# SERVICE BULLETIN

DATE: 20 JULY 2011 PAGE 1 OF 6

# **REPLACEMENT OF MOBIL SHC 626 WITH MOBIL AGL**

#### Figure 1. Removal and Replacement of Mobil SHC 626 References

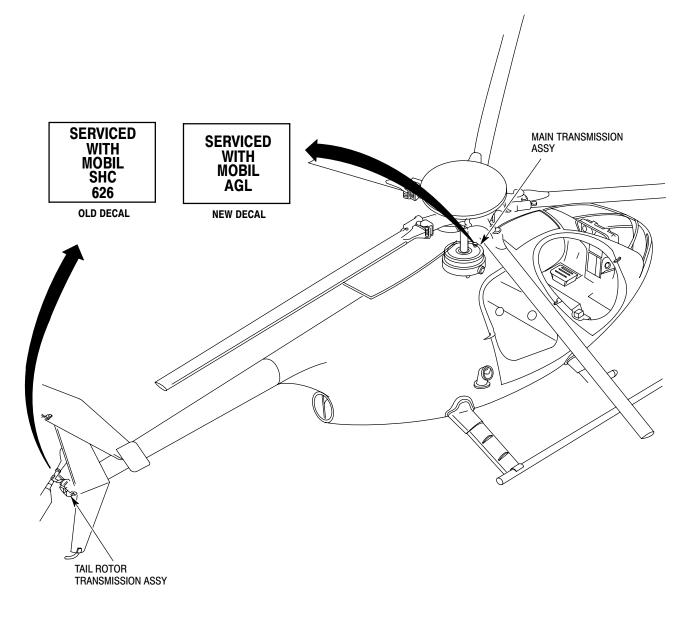
#### A. <u>Remove and Replace the Oil Usage Decal at the Main Transmission Assembly</u>

- (1). Remove the fan hub and transmission cover fairing (ref. CSP-HMI-2, Section 53-30-30; not applicable for 369H, 369HE, 369HM, and 369HS models).
- (2). Remove the old decal from the mast support pan.
- (3). Clean the old adhesive from the mast support pan (ref. CSP-HMI-2, Section 20-20-00).
- (4). Install the new decal on the mast support pan.

#### B. <u>Remove and Replace the Oil Usage Decal on the Tail Rotor Transmission</u> <u>Assembly</u>

- NOTE: Not applicable for 369H, 369HE, 369HM, 369HS, 500N, and 600N rotorcraft.
  - (1). Remove the old decal from the tail rotor transmission assembly.
  - (2). Clean the old adhesive from the tail rotor transmission assembly (ref. CSP-HMI-2, Section 20–20–00).
  - (3). Install the new decal on the tail rotor transmission assembly (ref. CSP-HMI-2, Section 11–00–00).
